67 PP

DA (AMENDED)

67 PP
67 Pacific Parade DEE WHY NSW 2099

**BENSON
McCORMACK
ARCHITECTURE**

DRAWING TITLE
GENERAL
ARRANGEMENT -
LOWER GROUND
PLAN

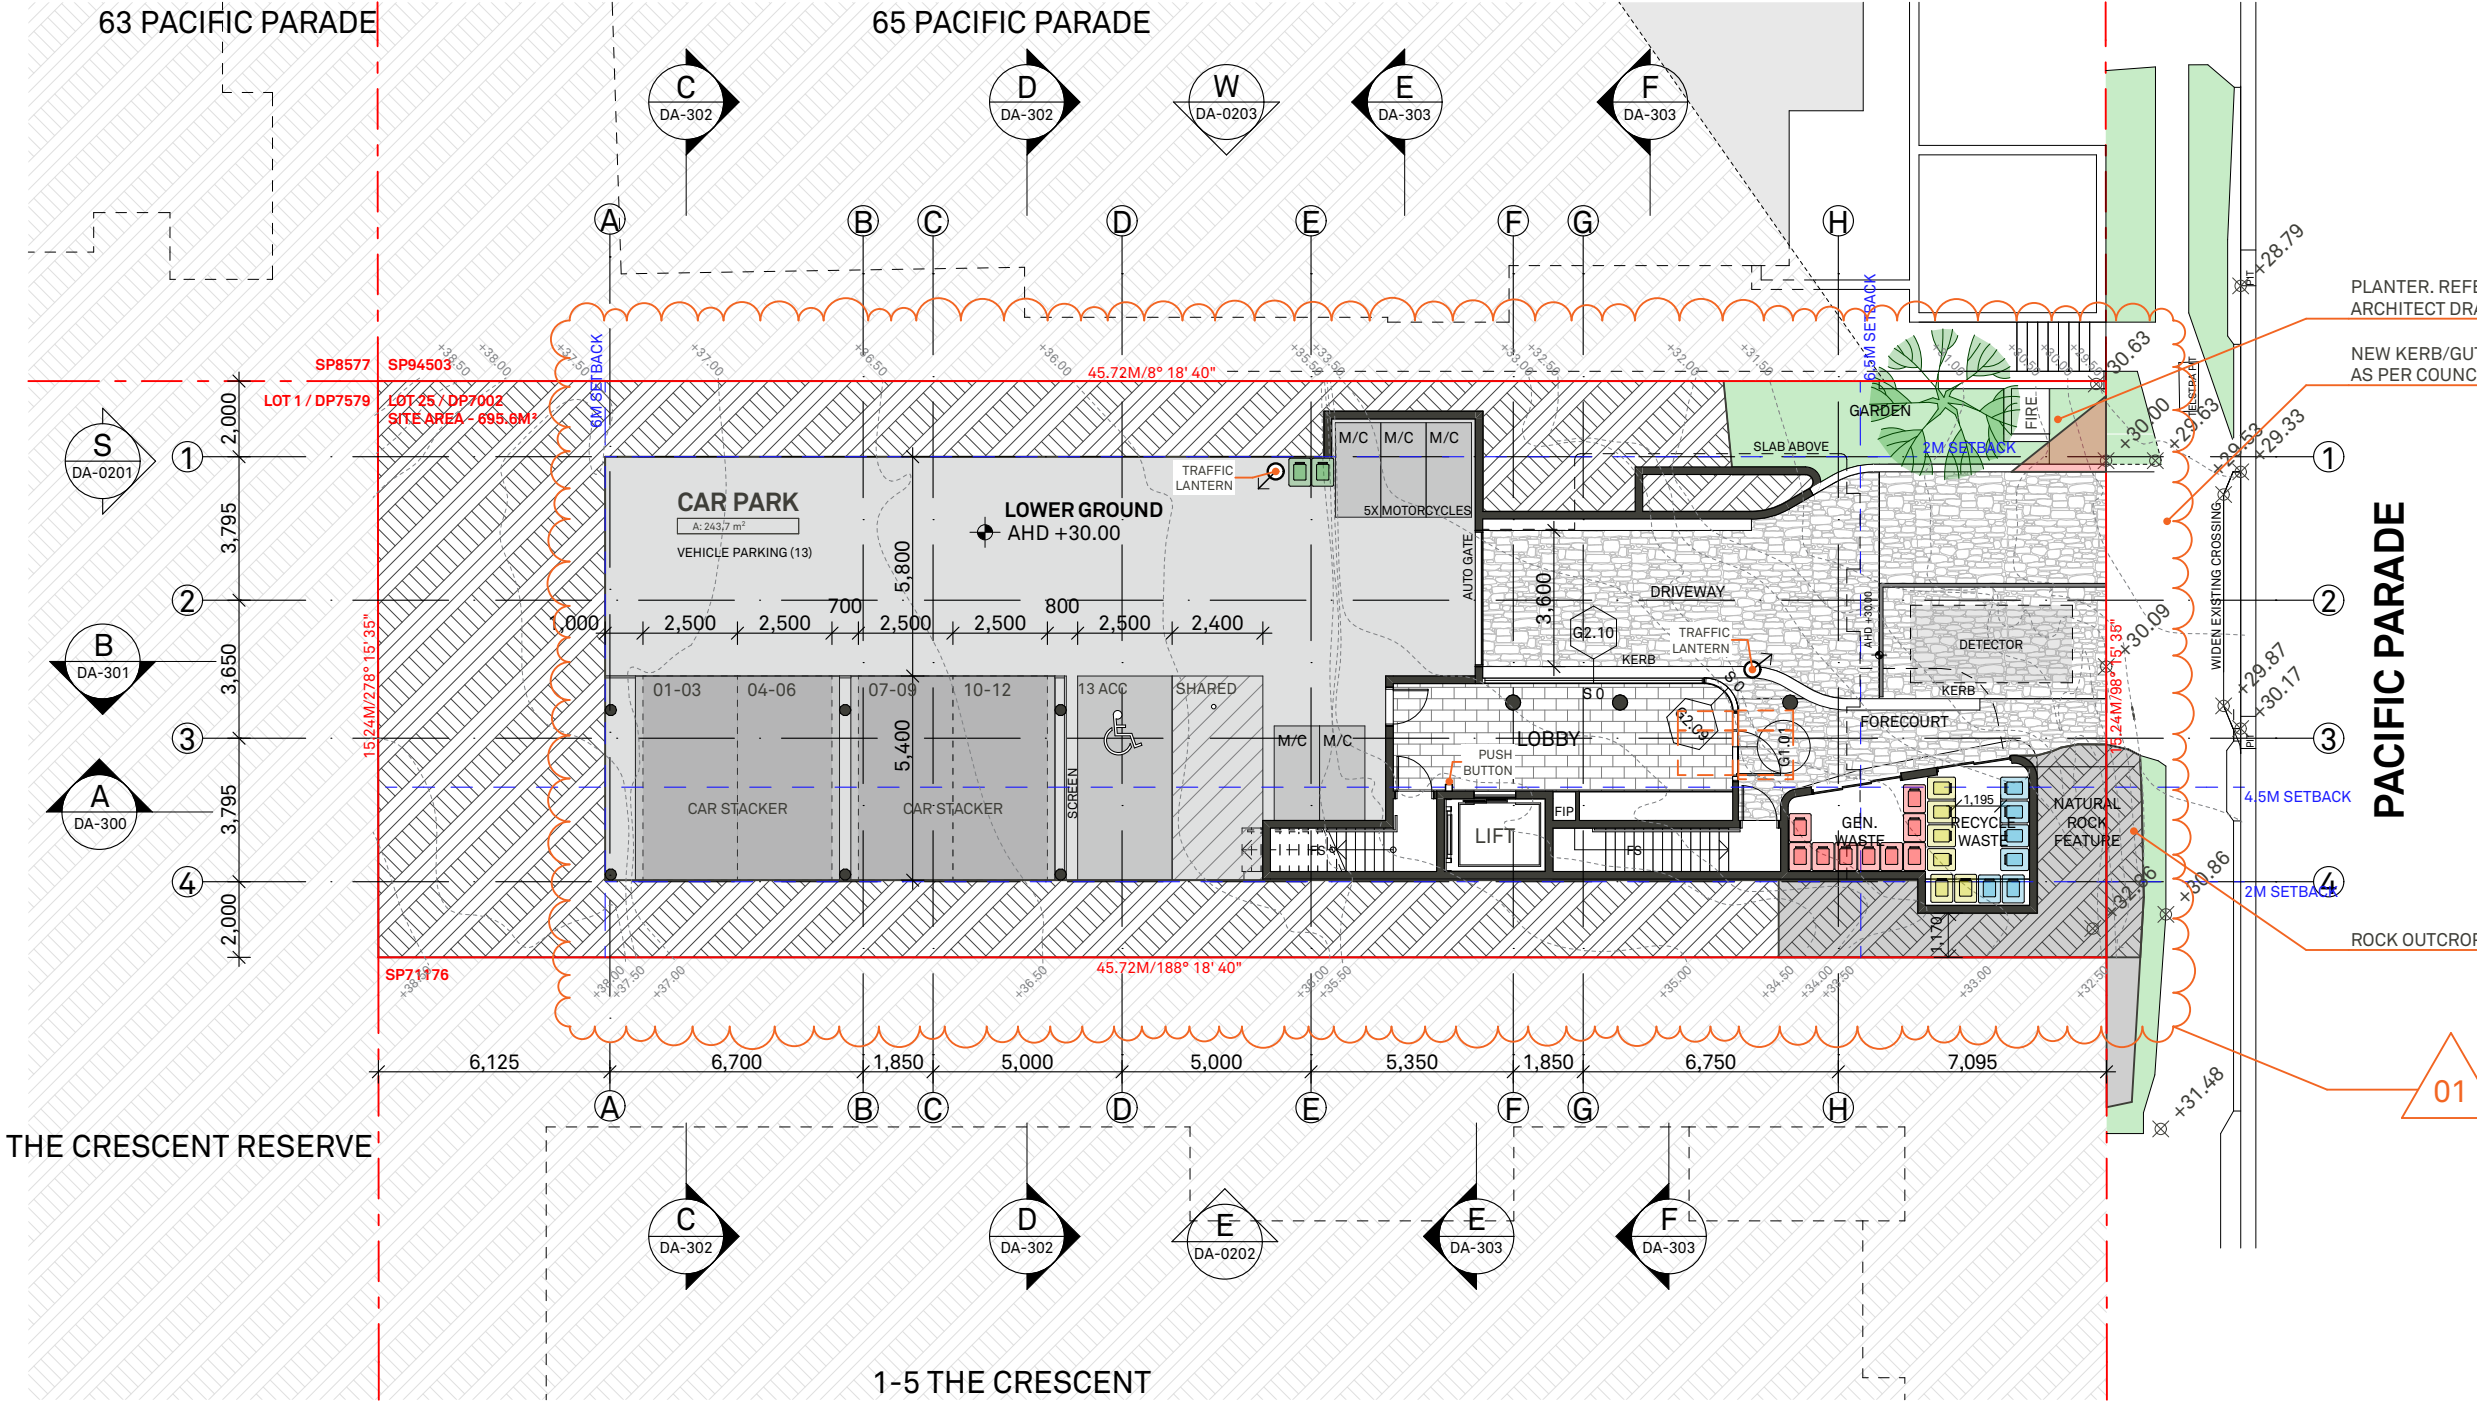
- 01 REMOVE VEHICULAR ACCESS TO BASEMENT;
INSTALL CAR STACKING MECHANISM (12 CARS);
INSTALL INTERNAL TRAFFIC LIGHT SYSTEM;
PROVIDE 1x ACCESSIBLE CAR SPACE; 5x MOTOR-
CYCLE SPACES; WIDEN VEHICULAR CROSSING;
INCREASE LANDSCAPING AREA AND INCREASE SOIL
DEPTH IN SOME AREAS; REMOVE GARBAGE
STORE AND REPLACE WITH HOLDING AREA

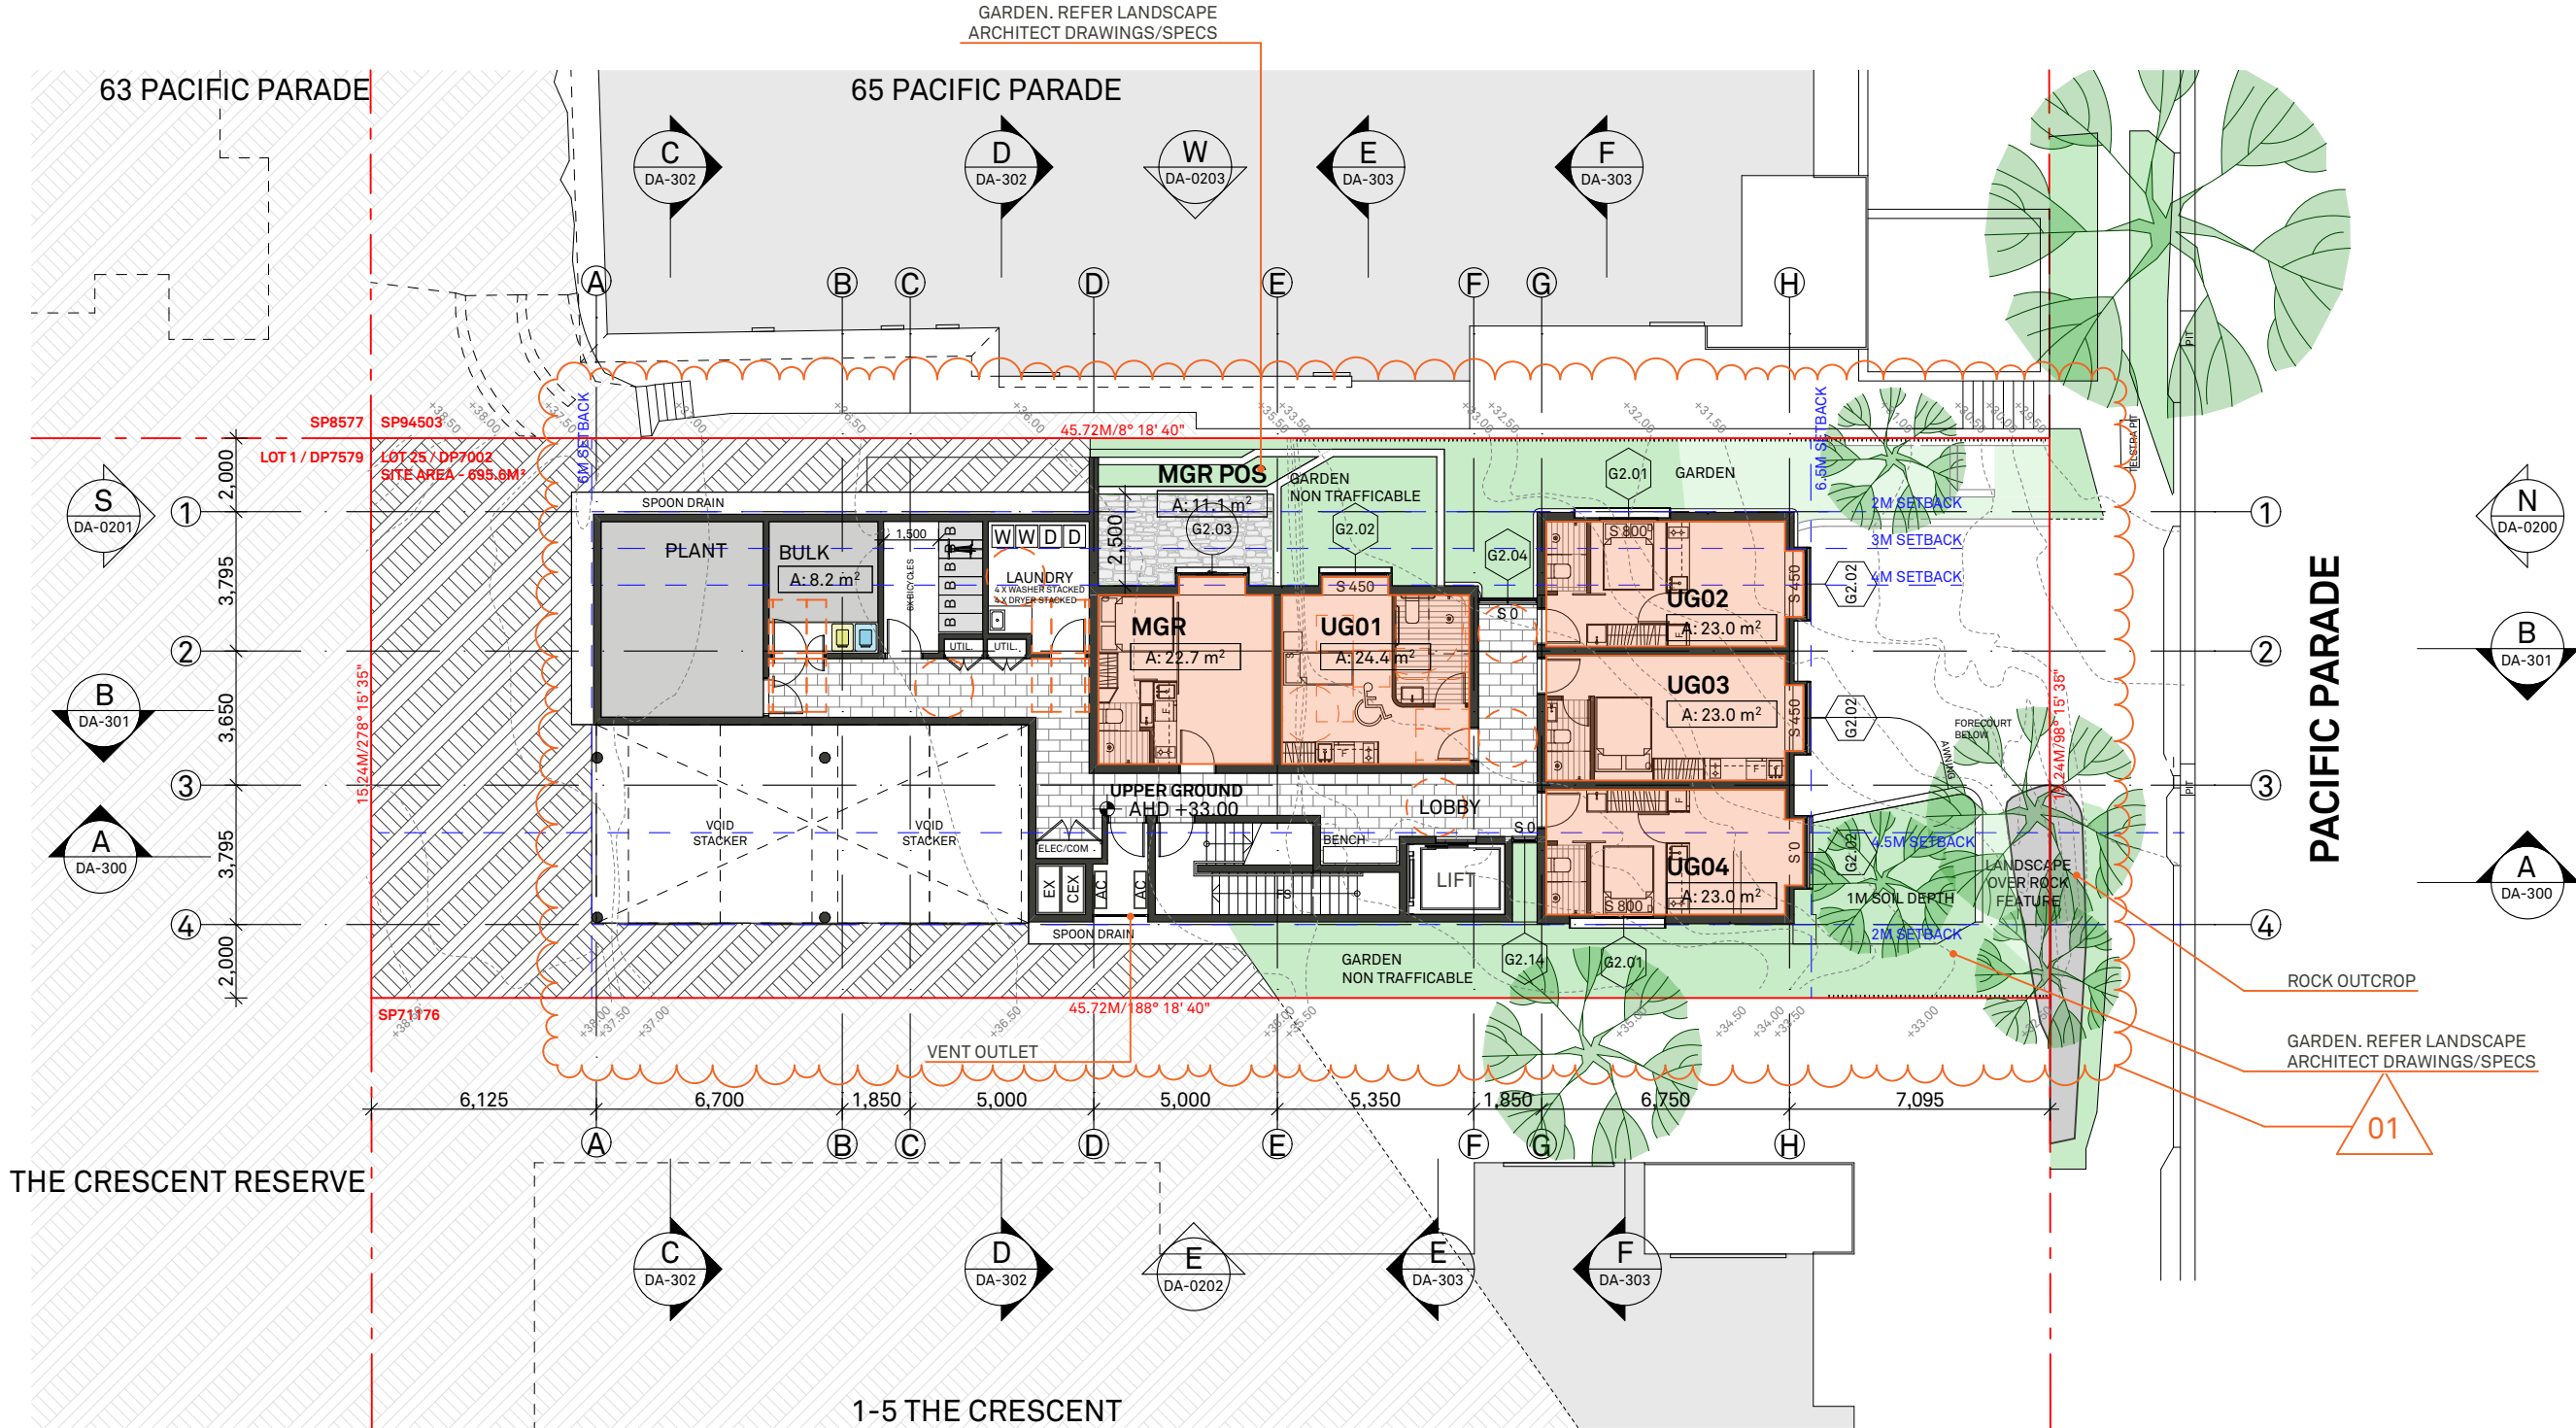
- 01 INSTALL CAR STACKING MECHANISM BELOW (VOID);
RELOCATE COMMON ROOM; REMOVE 1x ROOM; INSTALL
6x BICYCLE SPACES; RELOCATE LAUNDRY; INSTALL
GARBAGE AND BULK STORE WITH ADDITIONAL RECYCLING
BINS; REMOVE TRELLIS AND INCREASE AT-GRADE
LANDSCAPING AND SOIL DEPTH IN SOME AREAS;
RE-LABEL ROOM NAMES

DRAWING TITLE
GENERAL ARRANGEMENT - LEVEL 1 PLAN

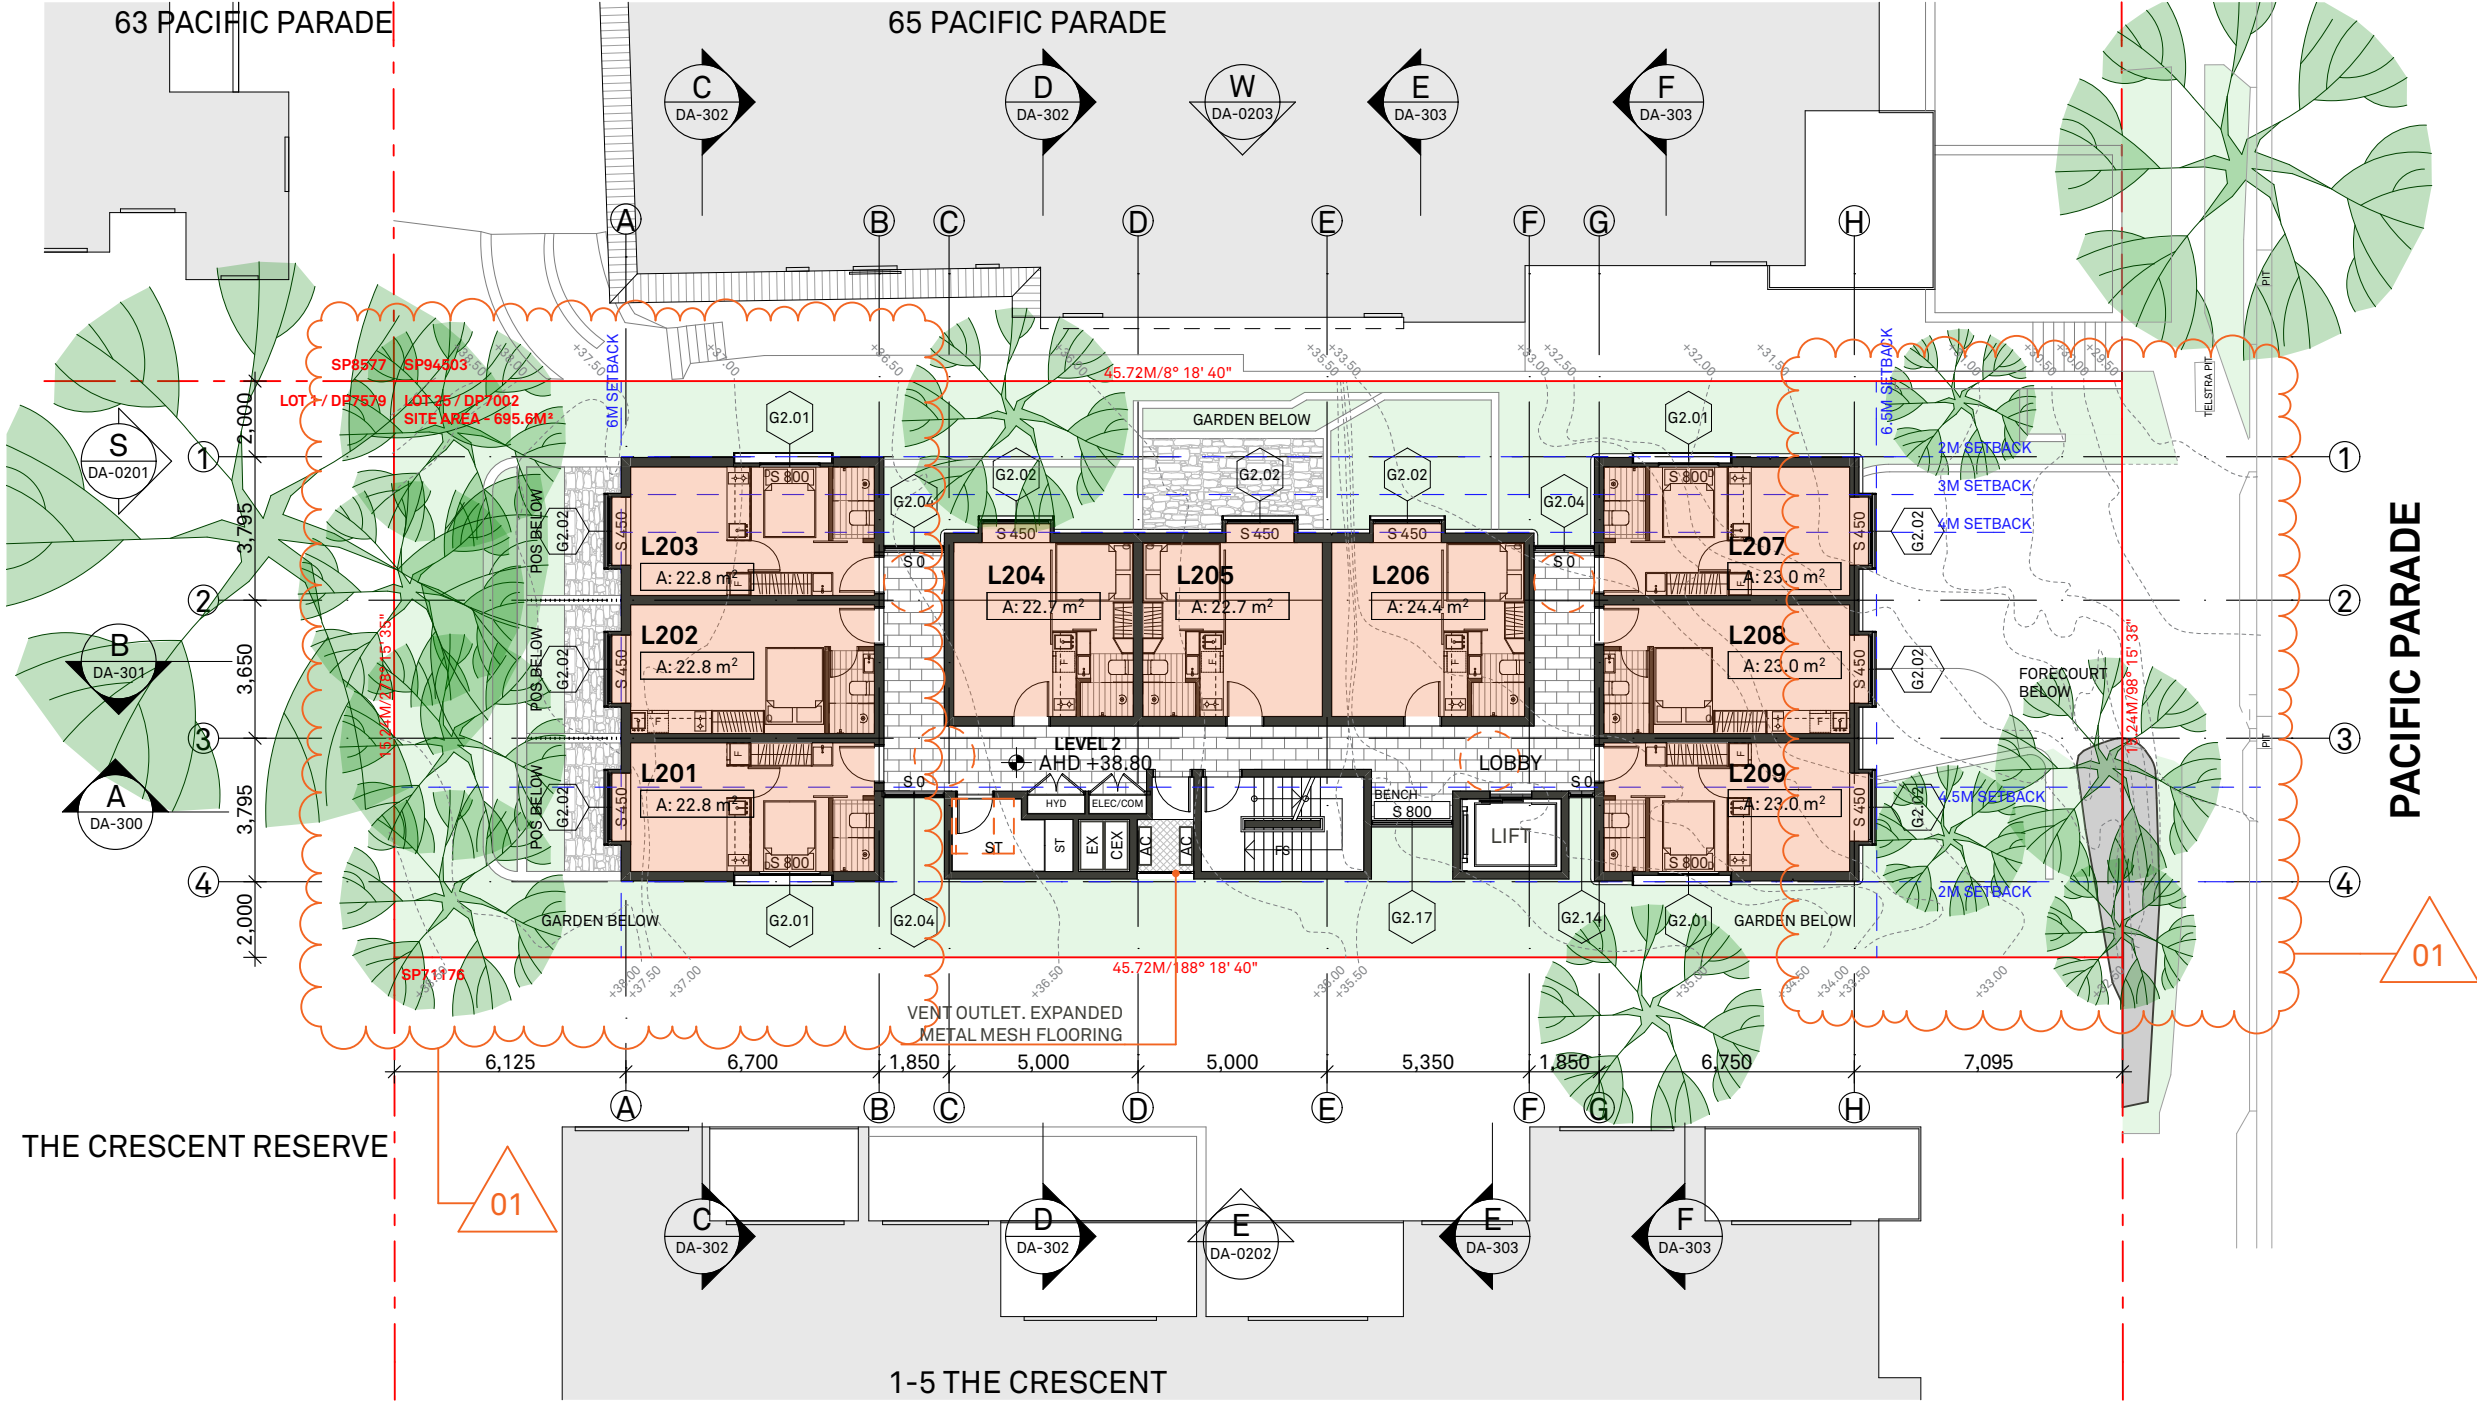
SUMMARY OF CHANGES
01 RELOCATE COMMON ROOM; INSTALL 3x ADDITIONAL ROOMS; REPLACE COMMUNAL OPEN SPACE WITH PRIVATE OPEN SPACE.
